PREFACE (INCLUDING RESPONSES TO COMMENTS)

The City of Riverside (City), through its Community & Economic Development Department, Planning Division (Department), is the lead agency responsible for the review and approval of the proposed Street Light Replacement for Areas 3–5B Project (project or proposed project). The City has made the determination that a mitigated negative declaration (MND) is the appropriate environmental document to be prepared in compliance with the California Environmental Quality Act (CEQA). Similarly, MNDs were prepared and approved for the previous lighting phases of Area 1 (Planning Case P12-0043) and Area 2 (Planning Case P15-0344) in 2012 and 2015, respectively. Based on light complaints from Area 1 of the Wood Streets Street Light Project, the need for tree trimming in some areas, and the potential for sidewalk detours during light replacement activities, mitigation measures were incorporated into the previous Area 2 phase. Similar mitigation measures are proposed for Areas 3–5B of the proposed project to ensure impacts are less than significant.

Street Light Replacement for Areas 3-5B Project

INTENTIONALLY LEFT BLANK

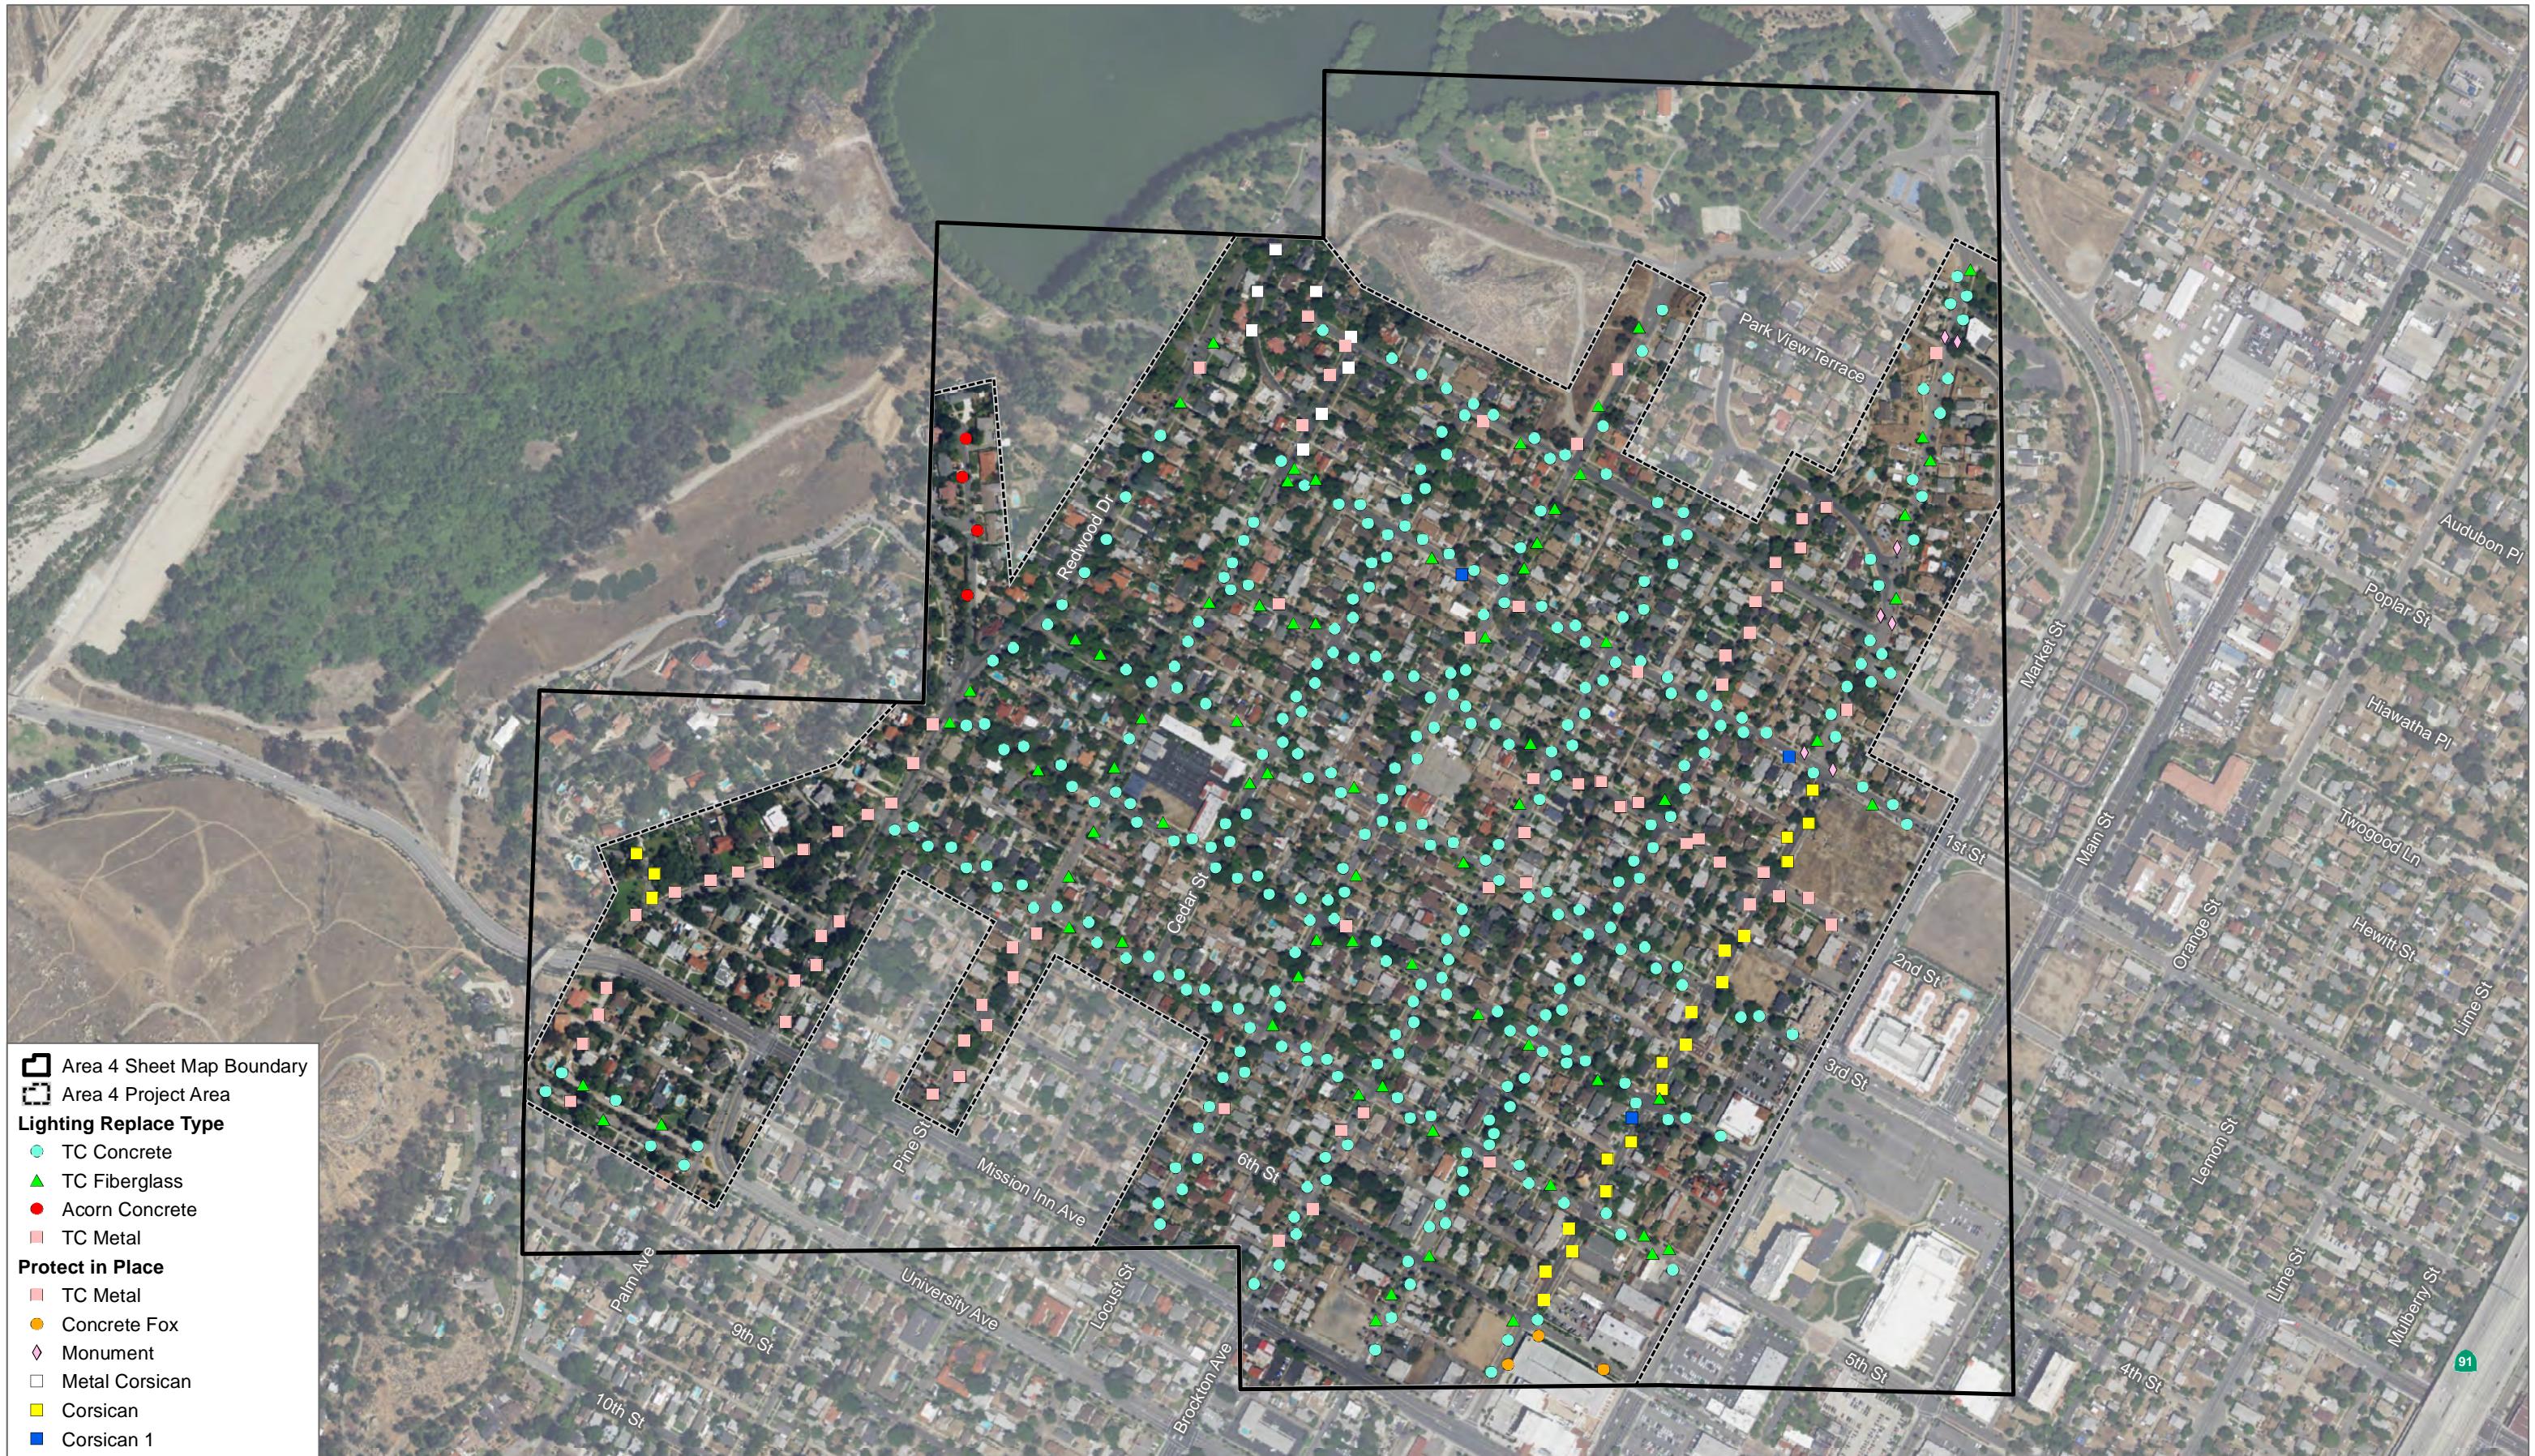
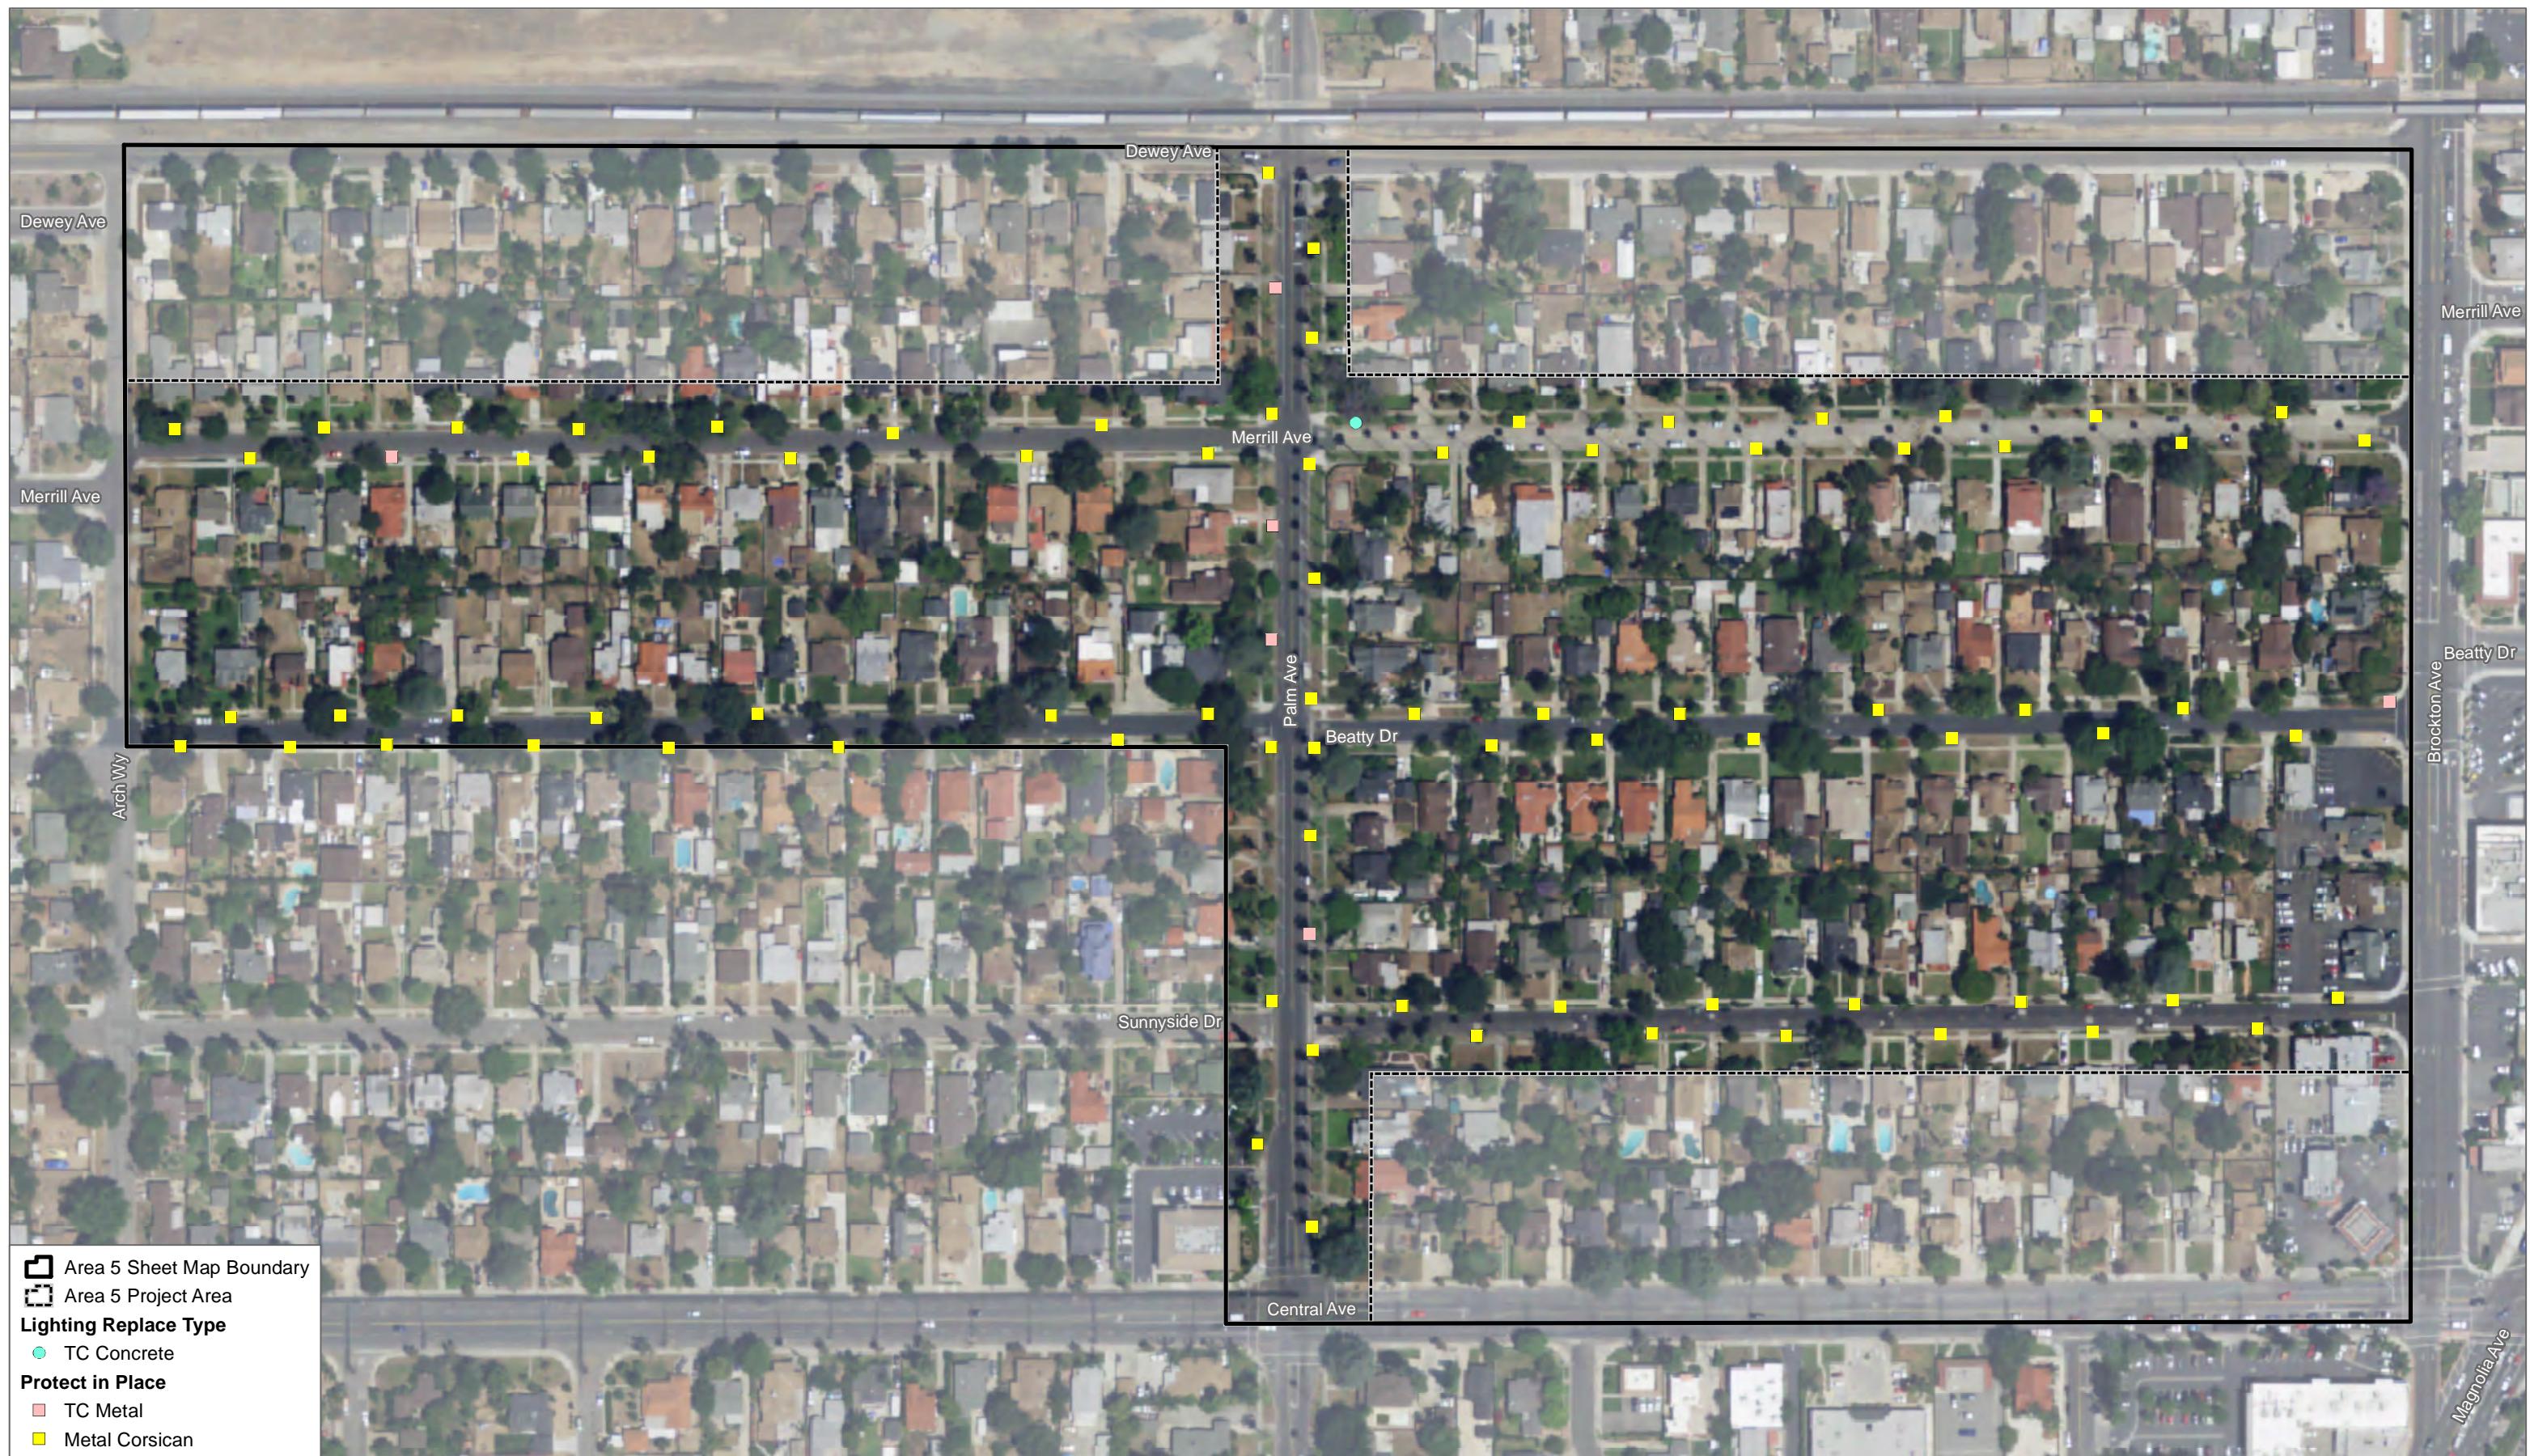
A-1 The commenter expresses concern regarding the height and location of the proposed streetlights, and potential impacts this may have on airplane hazards. Figures 3 through 7, included in the IS/MND, show all locations where the streetlights would be replaced. As discussed in IS/MND Section 4.2.5a, the proposed number and spacing of streetlights is based on American National Standard Practice for Roadway Lighting ANSI/IESNA RP-8 (RP-8), the standard approved by the Riverside City Council in 1996. As advances in lumen output technology have been made since installation of the existing historic streetlights, RP-8 Standards would actually reduce the number of streetlights needed per block to provide required lighting levels. Thus, the proposed project is expected to result in fewer streetlights than currently exist in Areas 3 through 5B. Provisions of the City's historic preservation ordinance, Title 20, the Secretary of the Interior's Standards for the Treatment of Historic Properties related to historic resources and design standards and guidelines, require that replacement streetlights look similar to existing ones. Thus, it is expected that replacement streetlights would be similar in height to existing streetlights. More specifically, the design details of the proposed replacement streetlights, including the proposed height of the streetlights, have been incorporated as Figure P-1, Replica Kodiak Replacement Streetlights Details, and the design details of the proposed luminaires have been included as Figure P-2, Proposed Luminaire Details. As shown in these figures, the standard and luminaire, together, indicate a total installed height of 14 feet and 3.5 inches. It should be noted that the height of the proposed replica streetlights is approximately 2 inches taller than existing streetlights. However, the existing direct embedment historic streetlights currently vary in height for a variety of reasons, such as the depth of the original excavation at the time of installation, soil compaction, minor changes in parkway elevation due to landscaping changes, settlement, and intrusion by tree roots. It should also be noted that although not all the streetlights would be replaced in the exact same location as the existing streetlights, replacements would be made in the same general locations (either adjacent to or across the street from existing streetlights). Further, the proposed streetlights are not expected to exceed the heights of other structures in the areas, including two- to three-story existing structures in the area, telephone poles, palm trees, etc. Lastly, as discussed in Section 4.2.8d, although part of the project site is located within Compatibility Zone "Other Airport Environs" of the Riverside Municipal Airport, only uses that would be hazardous to flight (such as tall structures) are prohibited within this zone.. The City provided additional information regarding the height and location of the proposed streetlights to the commenter on October 3, 2018, and November 1, 2018.

B-1 Based on the information provided by the City, the commenter confirms that the height of the proposed streetlights are below the Federal Aviation Administration's threshold for height obstacle obstruction, and thus no potential issues regarding flight hazards are expected. No further response is required.
